4727 12th Avenue NE
APN: 674670-1970
Zoning: SM-U 75-240 (M1)
Overlay: University District NW Urban Center Village
Lot Area: 4500 sf
Current Use: Single Family Residential

EDG RESPONSE

SIXTH FLOOR

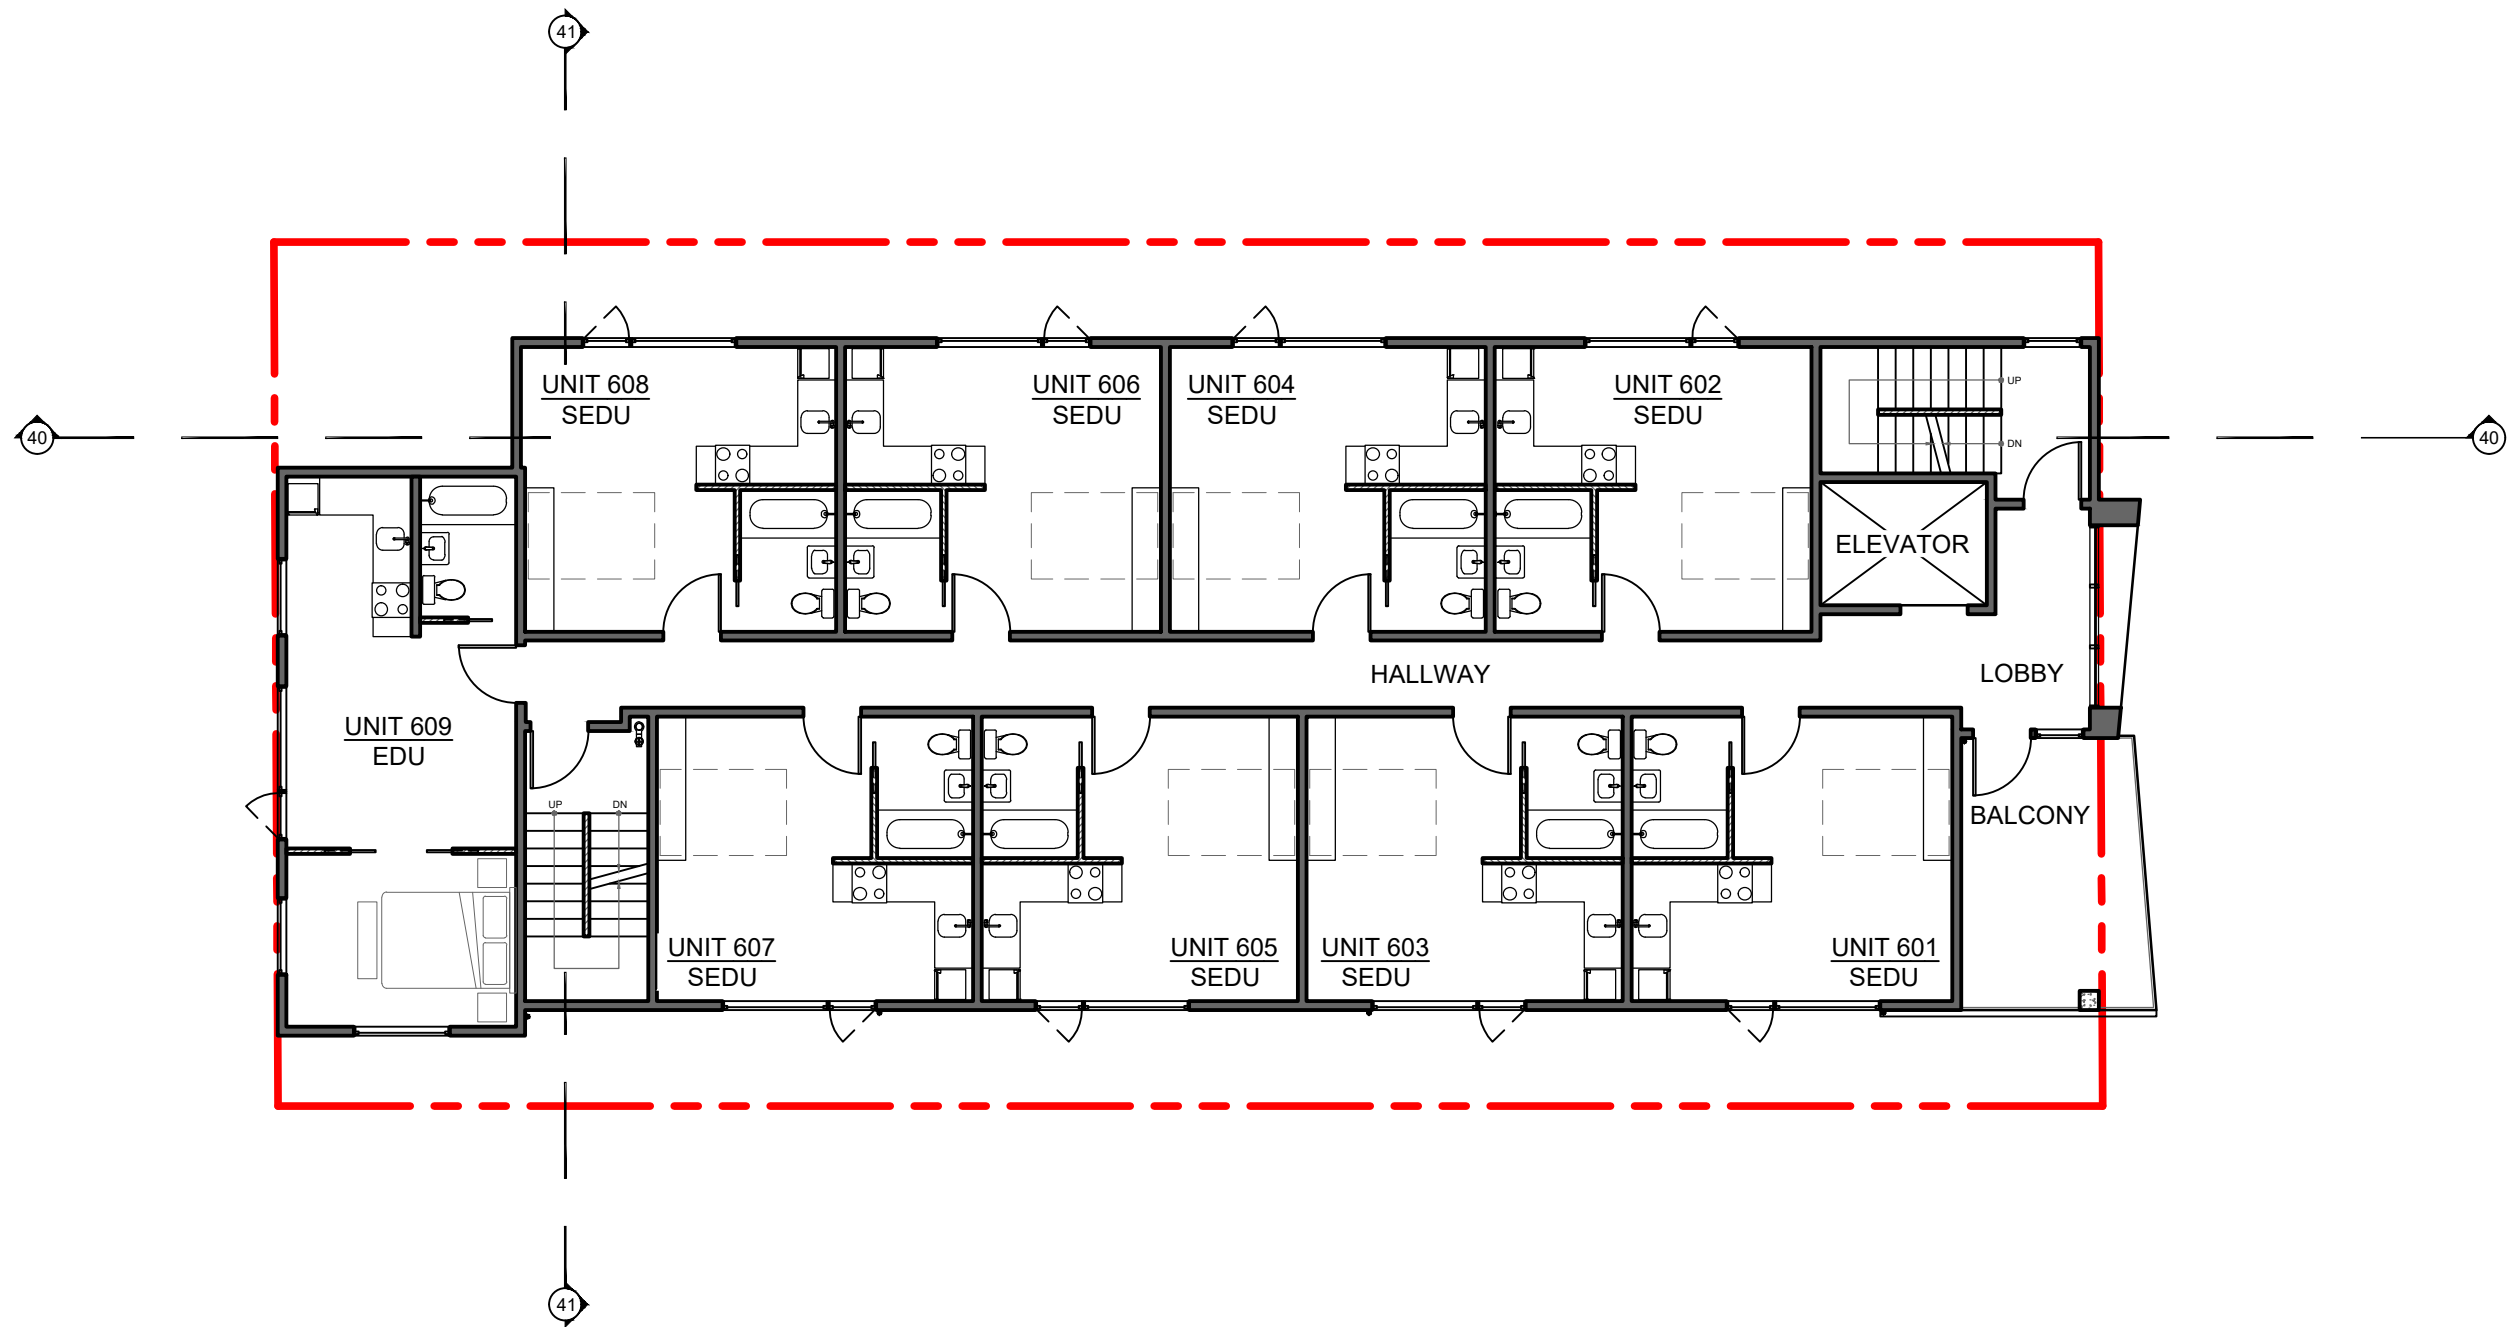
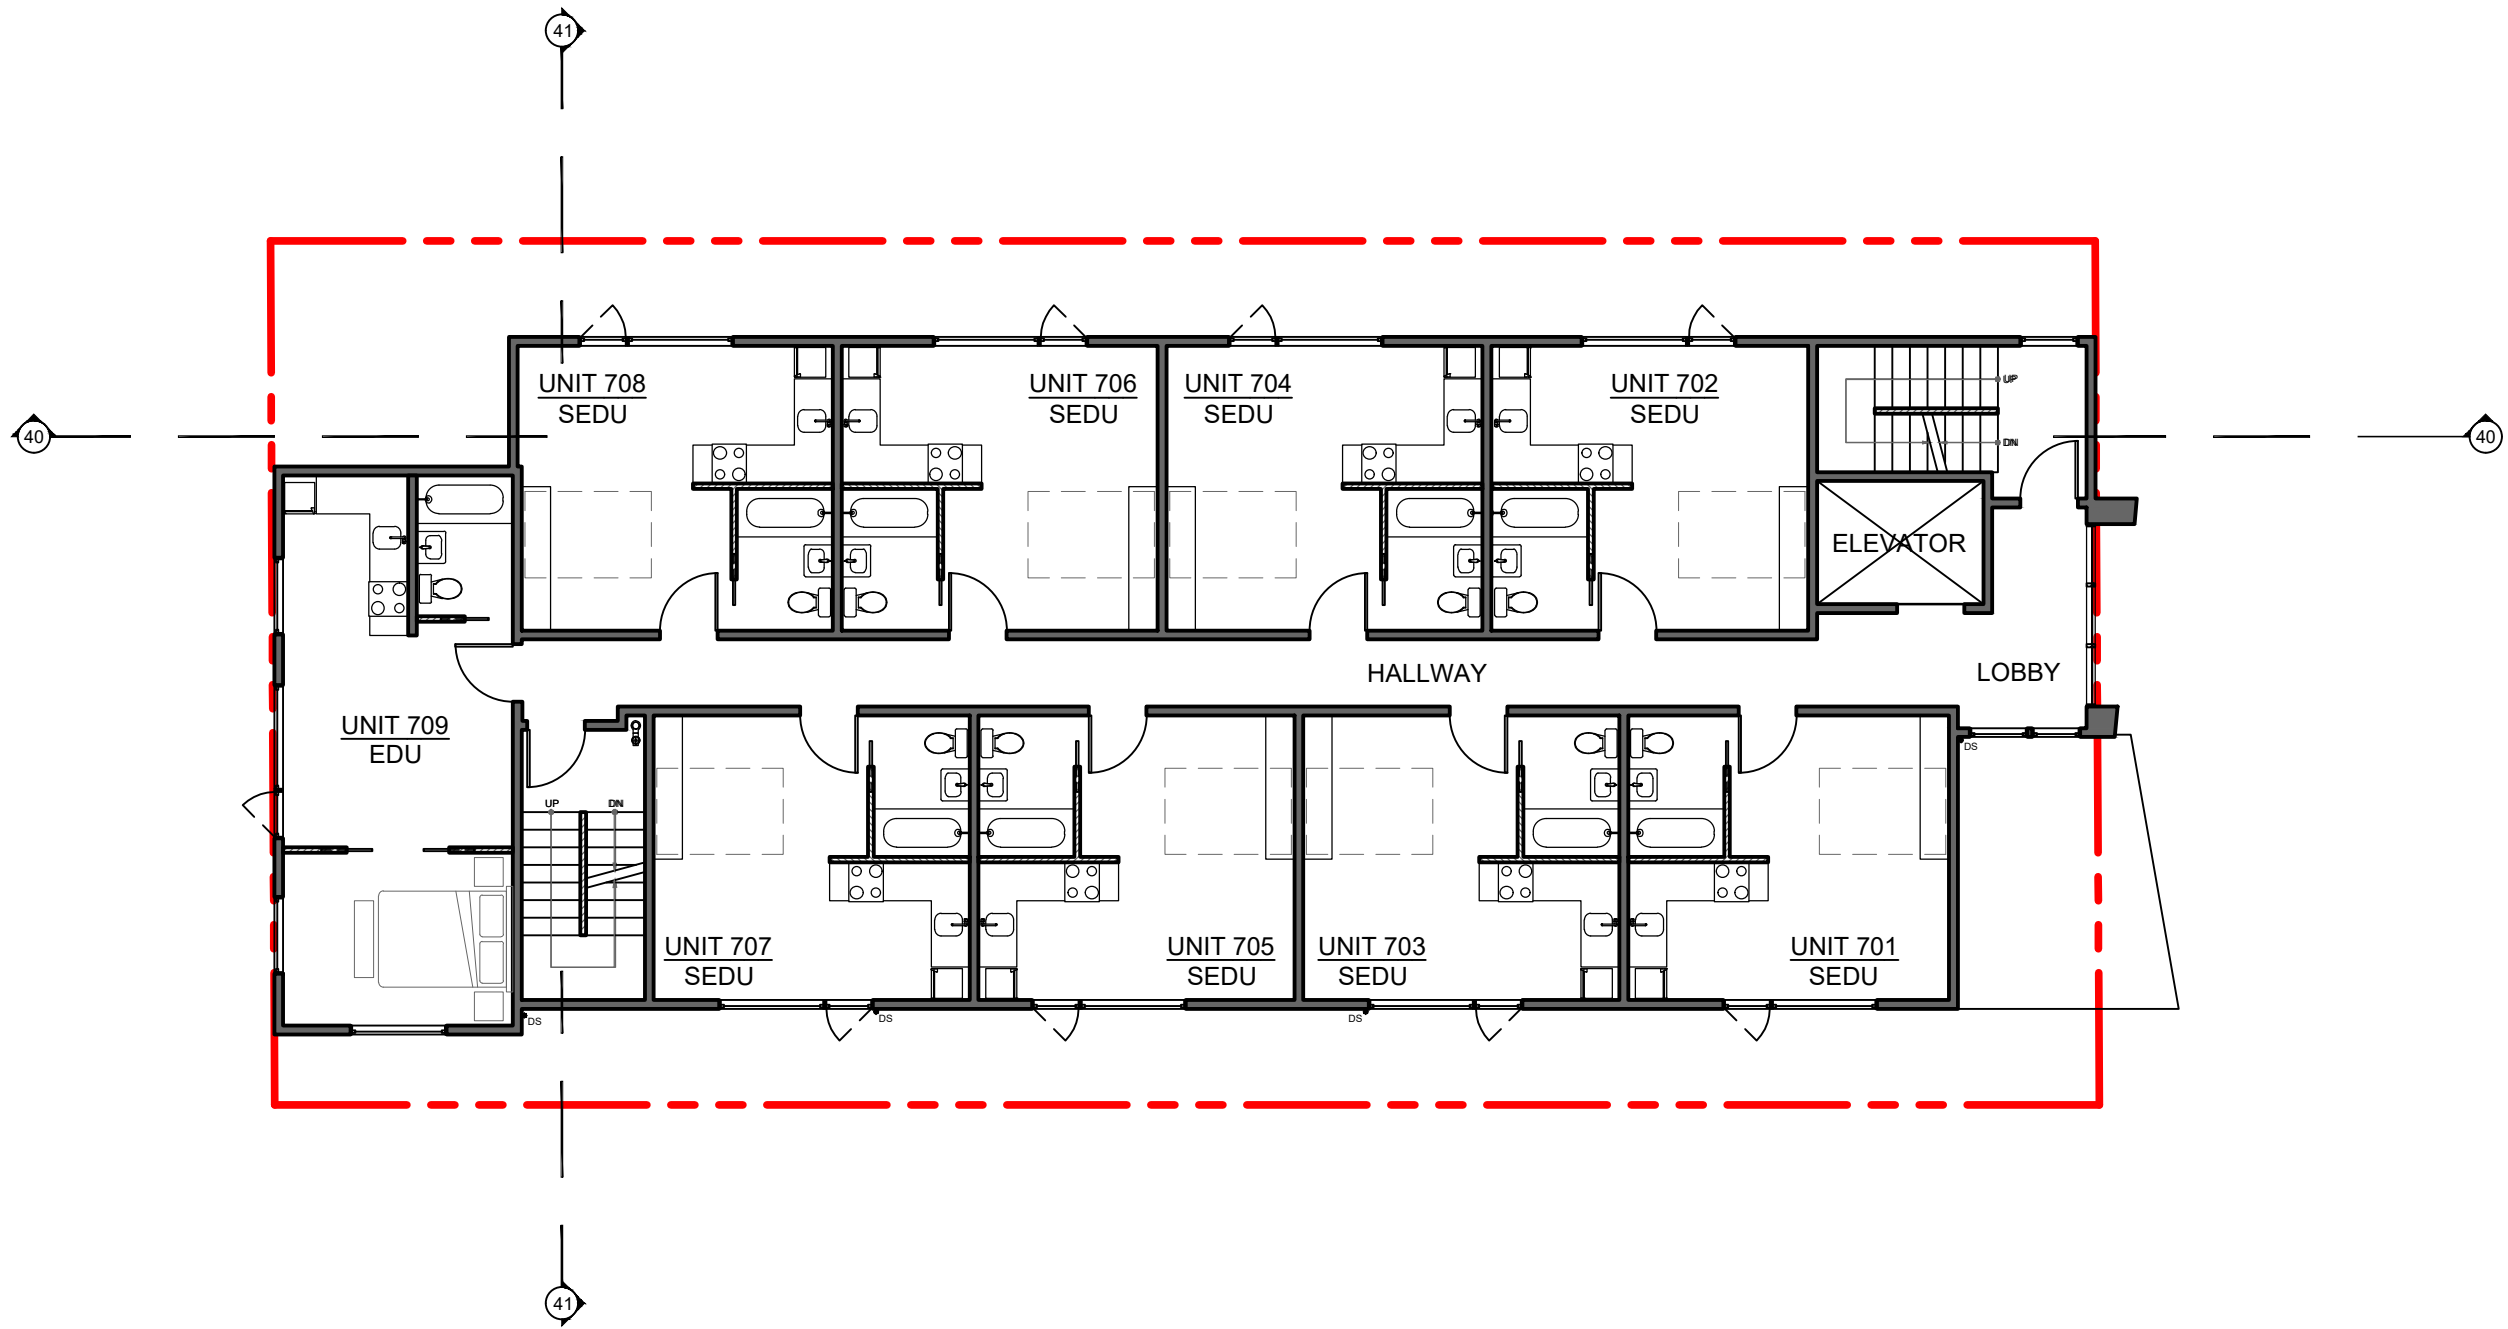
- At the EDG meeting, the following comments were provided:
- Asked if trash could be moved to the opposite side of the building.
 - Expressed concern that the ‘sunken’ walkways located along the north and south of the building designed as emergency egress for basement units will become throughways and loitering spaces for transients as they are connected directly to the alley. As such the commenter requested that gates be installed to discourage any unauthorized use of those walkway spaces.
 - The owner of the hotel expressed concerns about view impacts into their units and asked if floor level heights of the proposed structure would be the same as the motel.
 - Concerned that the building of 67 residential units without parking would be an impact and suggested that a building manager would even have a car – thus needing a place to park.

- While public concerns about the project not providing parking are not addressable, we have addressed the following items:
- The trash room was relocated to an interior enclosed room.
 - The sunken walkways will be outfitted with gates for security.
 - View impacts to adjacent buildings have been analyzed via fenestration diagrams and have been adjusted, where possible, to minimize overlap with neighboring doors and windows.
